memorandum

TO Selwyn District Council FROM Chris Bender
DATE 15 October 2021
RE Plan Change 69 – Odour Assessment Review

Figure 1: Lincoln Wastewater Treatment Pond

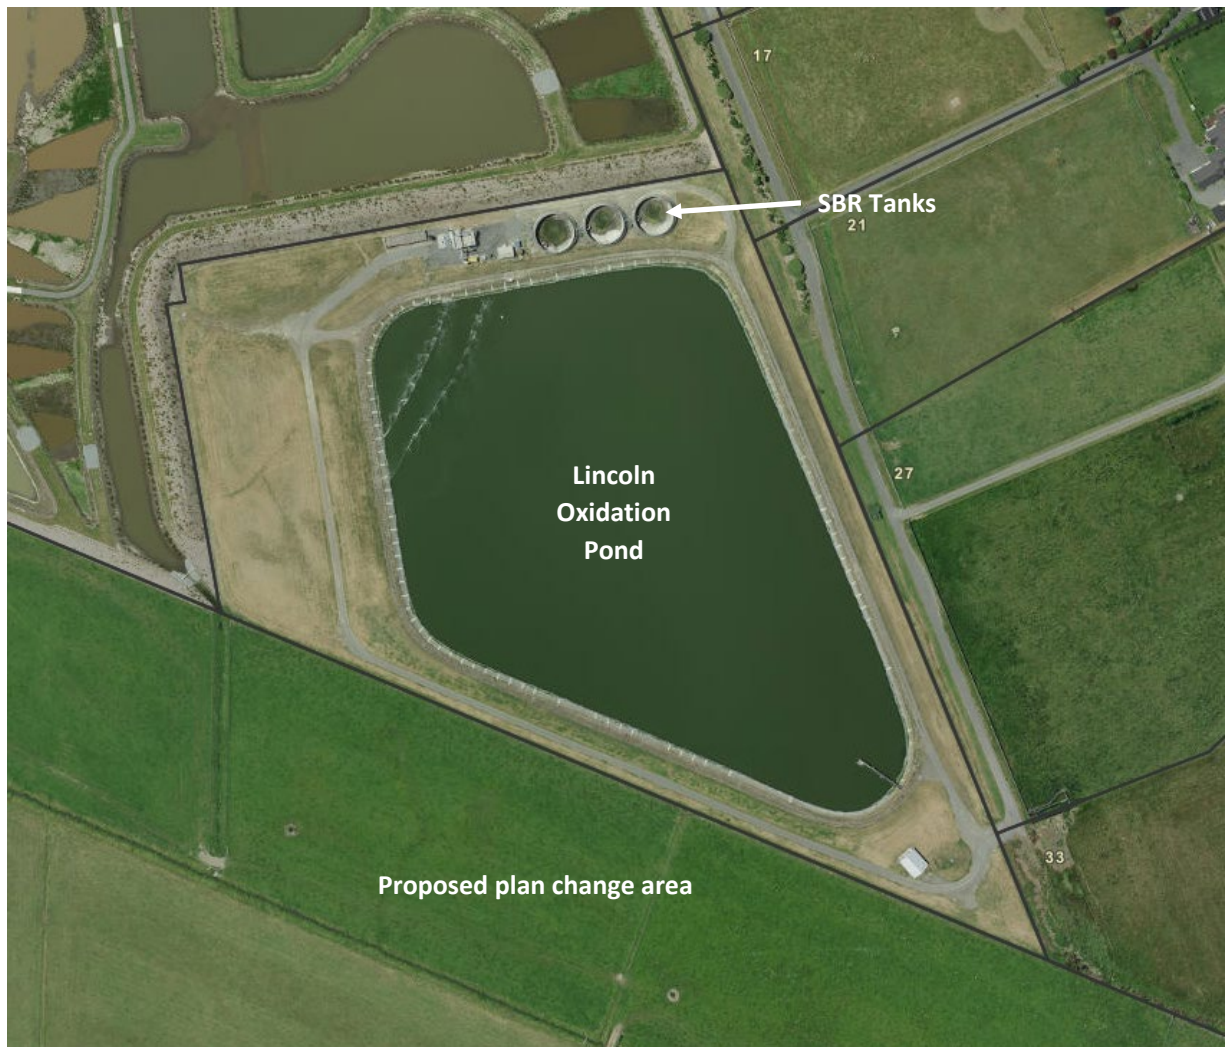
7. The Lincoln STP site is currently used as buffer storage in emergency situations where wastewater cannot be transferred to the Pines WWTP. The SBR tanks provide a combined 600 m³ of storage capacity for peak wastewater events, after which the wastewater overflows into the oxidation pond. The use of the site for emergency overflow storage are addressed in the Eastern Selwyn Sewerage Scheme Resilience Planning report¹, and include the following scenarios:

10. PDP agrees with the Golder assessment that the temporary storage of diluted wastewater in the SBR tanks and in the oxidation pond are unlikely to result in adverse odour effects beyond the site boundary. PDP notes, however, that the other potential scenarios resulting from pump failures or other infrastructure failures have not been considered. In these scenarios the wastewater would not be diluted with rainwater, and the time to repair the issues could potentially be greater. Consequently, the wastewater may become septic before such time as the failed infrastructure can be repaired and the wastewater disposed to the Pines WWTP for treatment.

11. PDP concludes therefore, that the failure of wastewater infrastructure that would necessitate the use of the SBR tanks and oxidation pond for storage of untreated wastewater has the potential to result in adverse odour effects. Odours of an offensive nature could be experienced beyond the site boundary if the wastewater is stored for an extended duration. However, PDP assumes such events would be an infrequent occurrence.
